Access Compliance Report

Public Rights-of-Way

(Curb Ramps)

Intersection ID: 48772	Main Street: SONOMA_VALLEY_DR	Cross Street: LUMBER_LN	Location: NE
ADA ID: 03EB5A495C5B	Ramp Type: PerpDiag	Initial Pass/Fail: Fail	Overall Compliance: No
Codes/Mitigation Info/Possible Solution		Field Measurements/Component Compliance	
Severity Score: 12.5

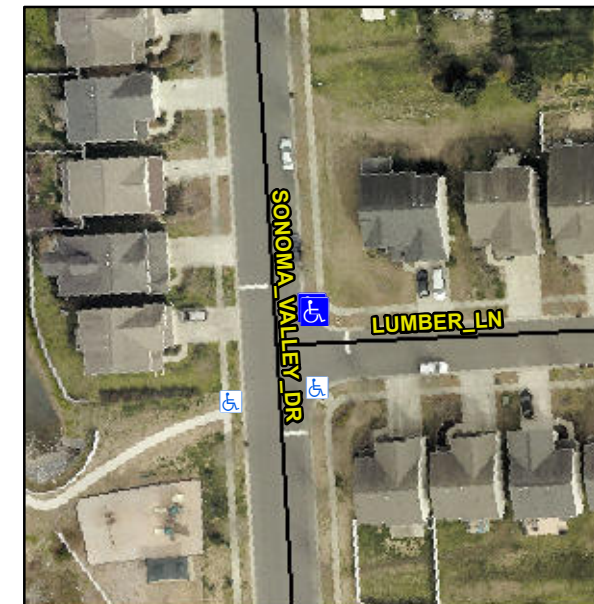
Not Found, R304.2.2

Compliance	Description	Data	Compliance	Description	Data
N/A	Ramp Length (in)	72.5	No	Ramp Slope (%)	9.4
Yes	Ramp Width (in)	48.0	Yes	Ramp XSlope (%)	1.3
N/A	Flare Type LT	N/A	N/A	Flare Type RT	N/A
N/A	Flare Slope LT (%)	N/A	N/A	Flare Slope RT (%)	N/A
N/A	Flare Traversable LT?	N/A	N/A	Flare Traversable RT?	N/A
N/A	Landing Length (in)	N/A	N/A	DWS Provided?	N/A
N/A	Landing Width (in)	N/A	N/A	DWS Contrast?	N/A
N/A	Landing Slope (%)	N/A	N/A	DWS Length (in)	N/A
N/A	Landing X Slope (%)	N/A	N/A	DWS Full Width?	N/A
N/A	Landing Curb? (Y/N)	N/A	N/A	DWS Offset (in)	N/A
N/A	Shared Landing?	N/A			
N/A	Gutter Ponding?	N/A	N/A	Gutter Slope (%)	N/A
N/A	Gutter Lip Ht (in)	N/A	N/A	Gutter X Slope (%)	N/A
N/A	Painted X Walk1?	No	N/A	Painted X Walk2?	No
	X Walk 1 Direction	To W		X Walk 2 Direction	To S
N/A	X Walk 1 Width (in)	N/A	N/A	X Walk 2 Width (in)	N/A
	X Walk 1 Slope (%)	0.3		X Walk 2 Slope (%)	0.2
	X Walk 1 X Slope (%)	1.8		X Walk 2 X Slope (%)	1.8

Remove & Replace Curb Ramp With Two New Directional Ramps or Equivalent.
